Central Valley Regional Water Quality Control Board
18/19 April 2024 Board Meeting

Response to Written Comments on
Tentative Waste Discharge Requirements for
Lincoln-SMD1 Wastewater Authority
Lincoln-SMD1 Wastewater Authority Wastewater Treatment and Reclamation Facility
Placer County

ATTACHMENT C – FLOW SCHEMATIC

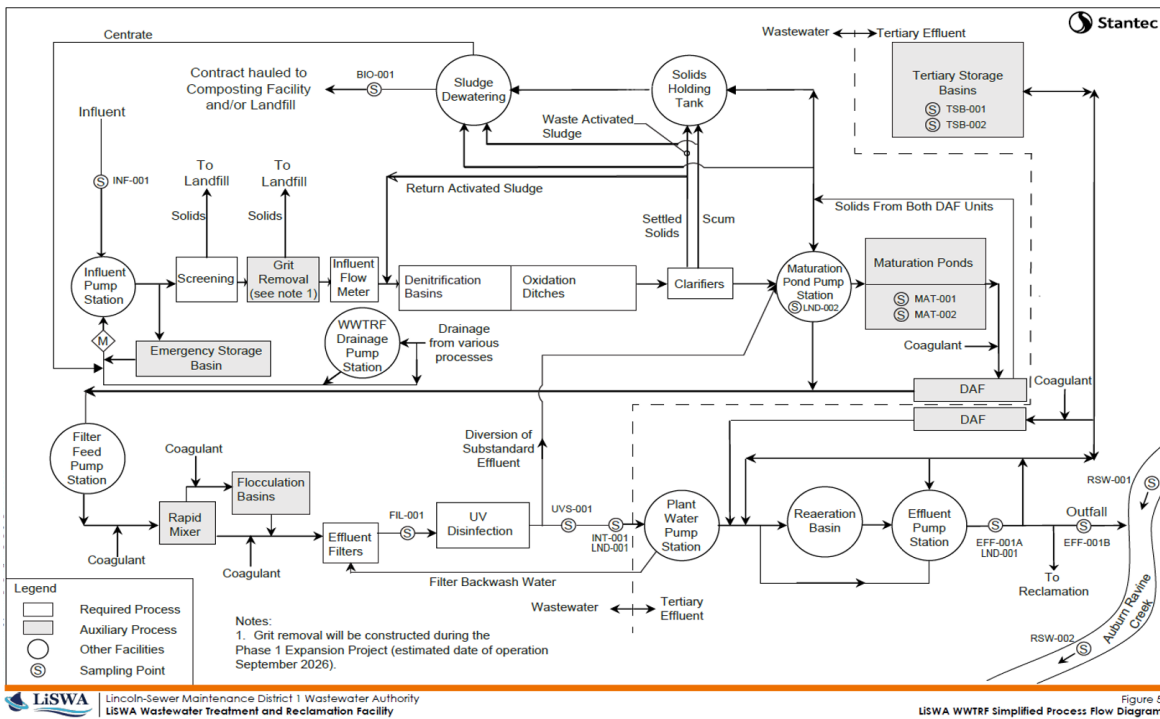
Discharge Point 003 in Table 2, Discharge Location, has the same latitude and longitude for monitoring locations EFF-001A and LND-001. Shouldn't it be the same as LND-002 (Latitude: 38°51'36"N, Longitude: 121°21'01"W)? The Flow Schematic, Attachment C, does not identify D-002, LND-002 (below EFF-001A), D-003, and LND-001.

RESPONSE: Central Valley Water Board staff concur. Staff have revised the proposed Order to correct the longitude and latitude for Discharge Points 002 and 003 as updated by the Discharger, along with a revised Flow Schematic that identifies Discharge Points 002 and 003 as well as LND-001 and LND-002, as follows and throughout the proposed Order as appropriate:

Attachment C – Flow Schematic has been updated with the following diagram:
